TECHNICAL EVALUATION REPORT

MASONRY WALL DESIGN

PEACH BOTTOM ATOMIC POWER STATION UNITS 2 AND 3

NRC DOCKET NO. 50-277, 50-278

SKETCHES OF WALL MODIFICATIONS

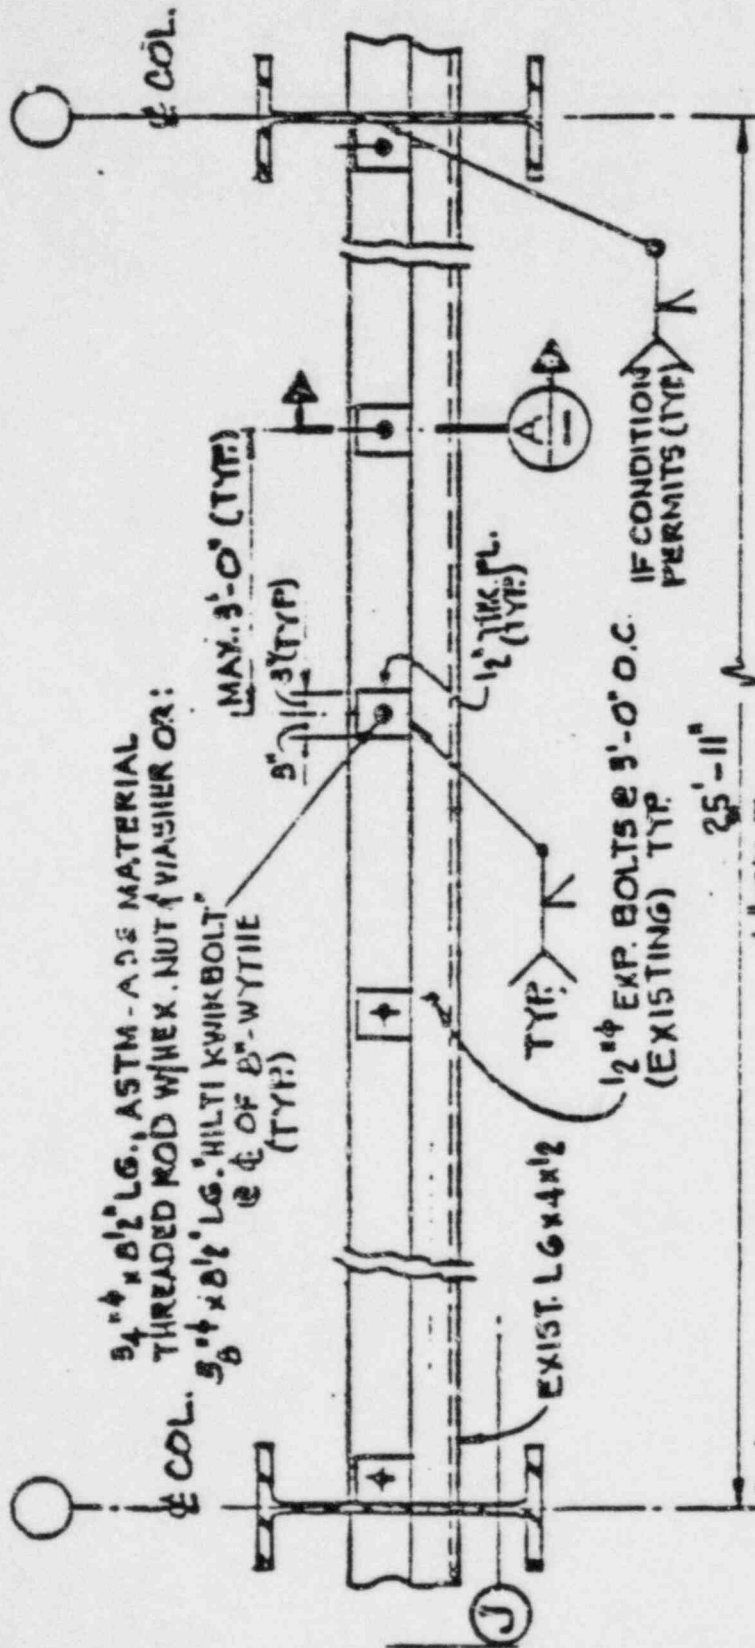
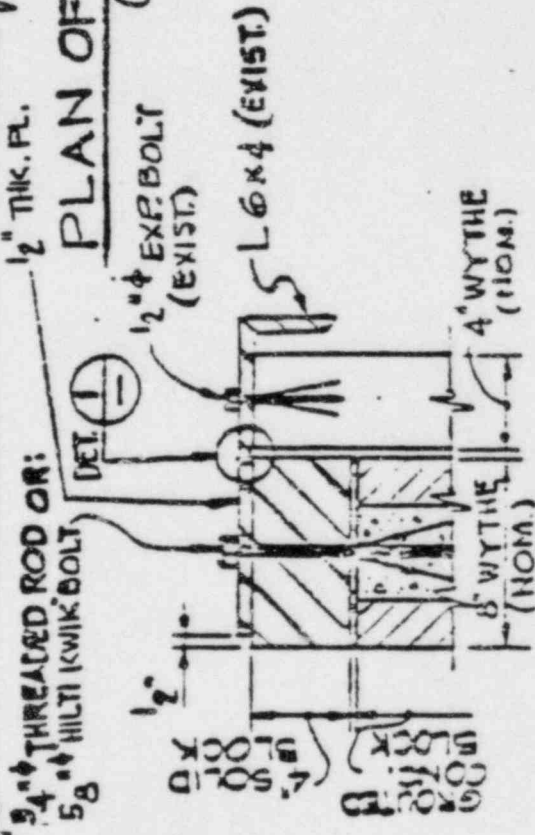
Provide details of proposed wall modifications and indicate, using sample calculations, how these modifications will correct the wall deficiencies.

According to the Licensee response, the wall modification improves the support condition at the top of the wall by connecting the two wythes. Before wall modification, mechanical connection of the top 6 X 4 angle was only to a 4-in wythe through 1/2-in diameter expansion bolts. A 1/2-in plate has been welded to the top angle and anchored to the 8-in wythe with 5/8-in diameter expansion bolts. The details of the wall modifications are given in Appendix B.

The Licensee indicated that the purpose of the modifications to these walls was to improve support conditions at the top of the walls by connecting the two wythes. This was accomplished by welding small 1/2-in plates at regular intervals to the existing restraint (a 6 x 4 angle), which was already bolted to the top of one wythe. The new plates were then bolted to the top of the second wythe, thus connecting the wythes. Refer to Appendix B for sketches of a typical modification.
